RELIABLE ENERGY'S COMMENTS ON NIPSCO'S 2021 INTEGRATED RESOURCE PLAN

March 24, 2022

Comments on NIPSCO's March 19, 2021 IRP stakeholder meeting and slide deck

Figure 9-43: Preferred Portfolio Capacity Addition Ranges by 2027

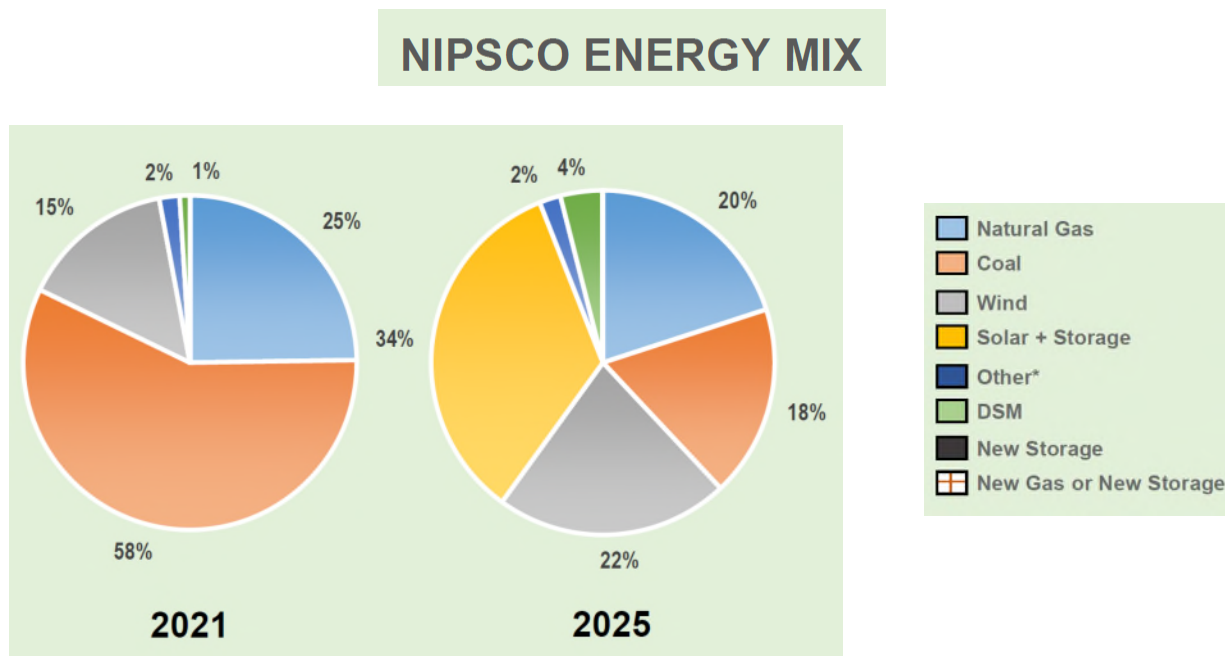
As shown in NIPSCO’s IRP Figure 9-43, the “Preferred Portfolio Capacity Additions by 2027”, there is not one proposed capacity resource addition that has confirmed terms or pricing. Firm pricing is not available for the Sugar Creek Uprate, no specific projects are identified (or costed) for the Solar + Storage DER Opportunities, no details are provided on the thermal capacity contracts, the DSM value is estimated, and the solar, storage and natural gas peakers are not defined. Yet, NIPSCO apparently believes this is the capacity plan upon which to act.

Figure 8-12: Reference Case Gas Price Forecast

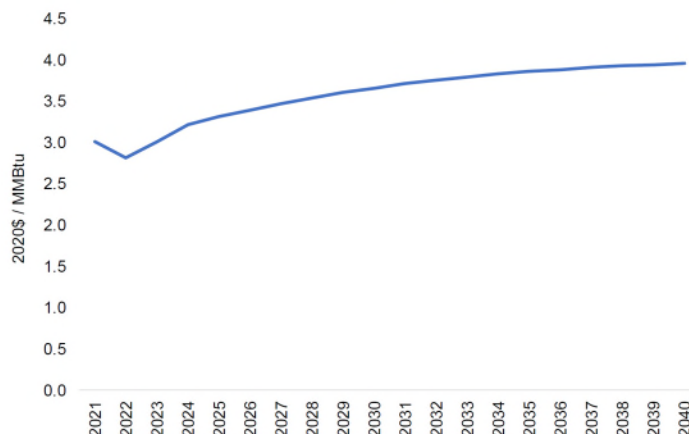
The increases were caused for a variety of reasons, some of which are believed to be situational, while others are believed to be structural. Regardless, the significant and somewhat sustained increase suggests increased pricing volatility and higher levels than assumed in the IRP:

The IRP also does not address the impact of the retirement of substantial amounts of coal capacity on natural gas prices. Coal and natural gas prices have capped each other over the last decade. This means when gas prices are high, coal generation increases, which reduces the demand for and price of natural gas. With the rapid retirement of coal plants, natural gas combined cycle plants will increasingly serve as the swing base load, yet there will be no coal generation to cap high gas prices.

Figure 8-43: MISO Zone 6 ATC Power Prices across Scenarios

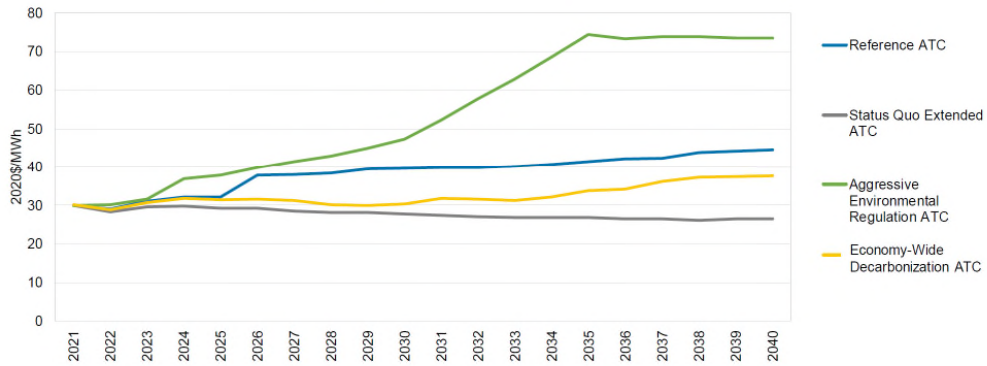
The replacement of base load coal capacity largely with intermittent renewables will increase NIPSCO's reliance on energy purchases from MISO. The outlook for MISO Zone 6 prices³⁵ did not reflect the high power prices experienced in 2021 and is similarly well below the forward curve for 2022 and 2023:

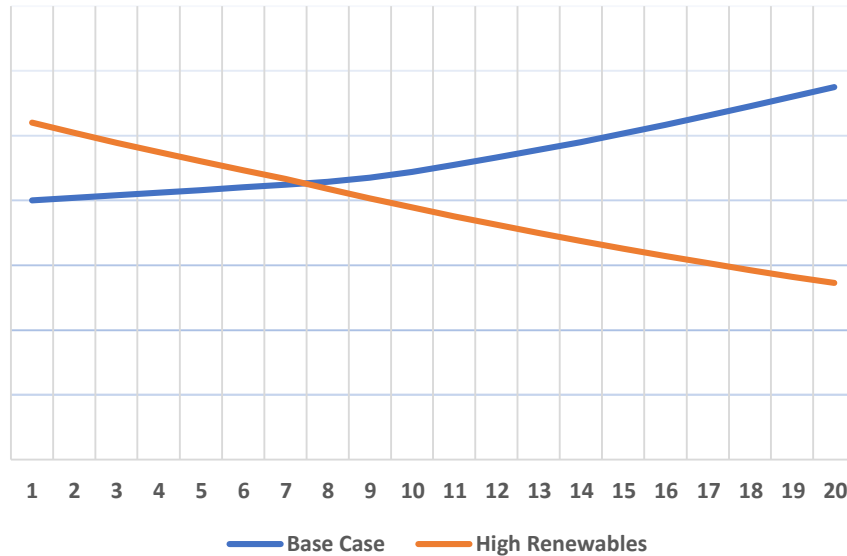
While it is appropriate for NIPSCO to consider the impact to customer bills, a 30-year net present value (NPV) is not a proxy for customer rates or affordability. A 30-year NPV is the discounted forecast of 30 years of annual revenue requirements. This is inappropriate for determining rate impacts for the following reasons:

- The revenue requirements are based on levelized costs: customer rates are based on undepreciated capital.
- A 30-year NPV can mask significant near-term costs with low future-year costs. For example, the following is a potential NPV of 20 years of annual revenue requirements.

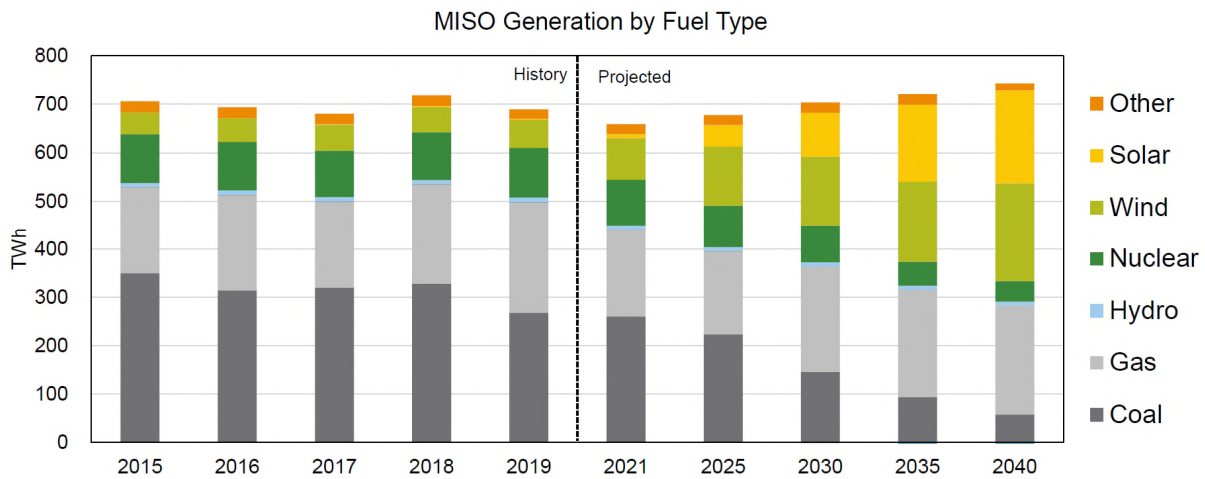
In addition, the forecast of MISO generation by fuel exceeds the levels at which MISO believes it can successfully integrate without significantly higher costs.
